# FOUR STROKE OUTBOARD PETROL ENGINE HOMOLOGATION FILE

Manufacturer: Tohatsu Outboards
Engine Model: MFS30B EP(T)(S/L)

**Running Production Changes**

#### **Update from Tohatsu 30B to Tohatsu 30C** Note:

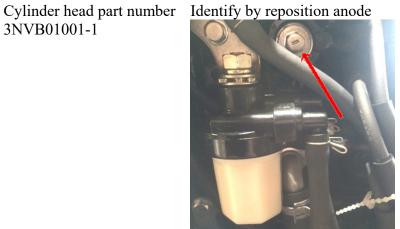
#### It is not allowed to use parts from Tohatsu 30B on Tohatsu 30C engine.

Part changed on the Tohatsu 30C

Tolerance Measure Unit Item Flywheel min 4 100 g part number 3AD-06191-0
